Areas of Specific Concern in the NIST WTC Reports

Below is a series of twenty-five provable points which clearly demonstrate that the reports produced by the National Institute of Standards and Technology (NIST) on the destruction of the World Trade Center (WTC) were unscientific and fraudulent. Therefore NIST itself – including its lead authors, Shyam Sunder and John Gross - should be investigated.

NIST WTC 7 exterior model results

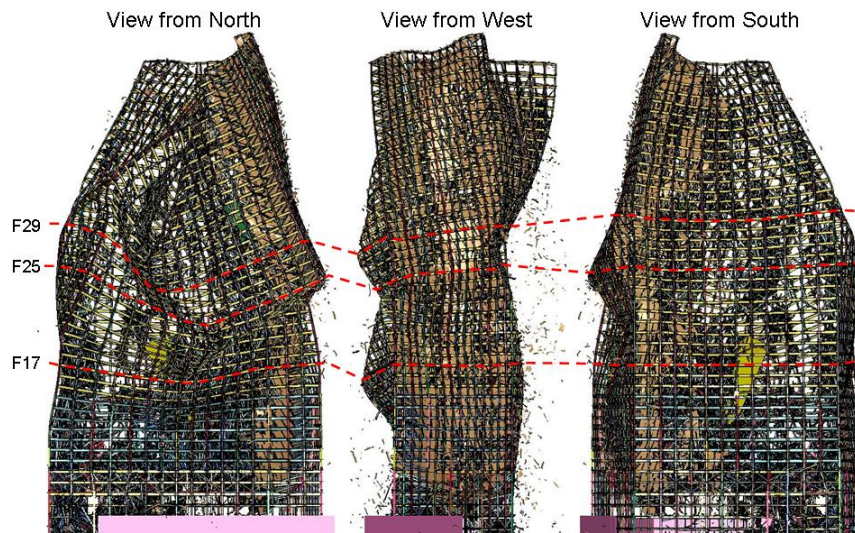
Technical Statement: The exterior of the NIST WTC 7 computer model shows large deformations, as would be expected in a natural collapse, but which are not observed in the video of the actual event. There is no attempt in the report to explain this discrepancy.

In footage of the actual collapse, the west penthouse and screen wall of WTC 7, which together span nearly half the length of the roof, start to fall one-half of a second prior to the full exterior collapse, yet the NIST report claims that the entire interior failed and completely collapsed prior to the exterior shell collapsing. Since there was little-to-no visible deformation of the exterior in the actual collapse and since the west penthouse and screen wall collapse timing indicates near-simultaneous interior and exterior failure, it seems clear that the severe deformation of the building’s exterior in the NIST model shows that their model does not replicate the actual collapse situation at all. The west penthouse and screen

wall drop starting just prior to that of the exterior is also indicative of controlled demolition, where the interior columns are severed just a fraction of a second prior to the exterior, in order to create an inward pull on the exterior and keep the debris contained within the building's footprint.

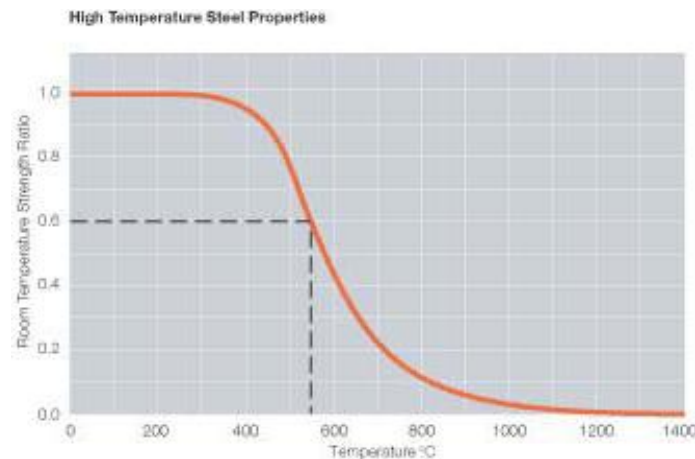
Technical Statement: NIST claims that the aircraft impact debris in WTC 1 stripped the fireproofing materials from the floor truss assemblies — even on the opposite side of the building from the impact — to the point where the floor assembly steel was then vulnerable to fire. NIST attempted to validate this hypothesis with ballistic firing equipment, firing buckshot and shrapnel at steel plates and bars coated with SFRM (Sprayed on Fire Resistant Material). During the testing, the gun was fired at velocities of approximately 500 ft/s and produced damage to the SFRM, but at one point it misfired and produced a projectile velocity of just 102 ft/s (31 m/s), which resulted in no damage to the SFRM.

WTC 1 was impacted on the north side of the building. NIST claims that the fireproofing was stripped from the trusses on the south side, causing them to sag and pull the south face of the building inward, initiating the collapse. However, NIST’s own analysis of the aircraft’s deceleration, 0.40 seconds after impacting WTC 1 on the north face, shows the debris field moving at approximately 51 ft/s (15 m/s) as it enters the floor assembly area on the south side of the building. How can NIST justify the aircraft debris damaging the SFRM on the floor assembly steel on the south side of the building when their own testing and analyses seem to rule it out?

- Two velocity charts below

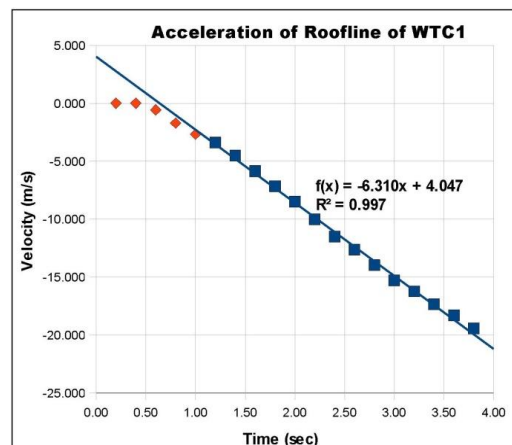
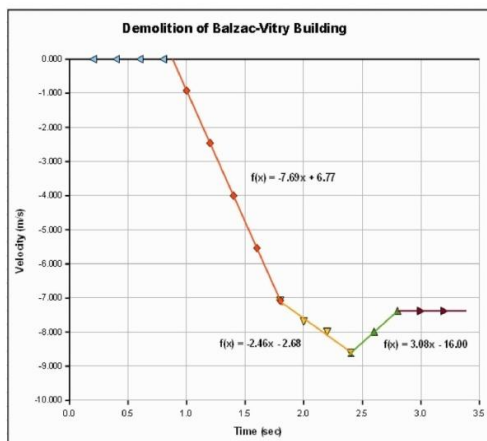
The velocity graphs of the upper sections of both a building demolished by the Verinage technique and that of WTC 1 are shown below. Note the abrupt reduction of velocity in the *natural* force collapse using the Verinage demolition method on the Balzac-Vitry building in France vs. the *continuous* acceleration of WTC 1. The columns in WTC 1 must have been

“removed” prior to impact. This can only be done by explosives — for which there is abundant evidence, as outlined in the documentary film, *9/11: Explosive Evidence—Experts Speak Out*.
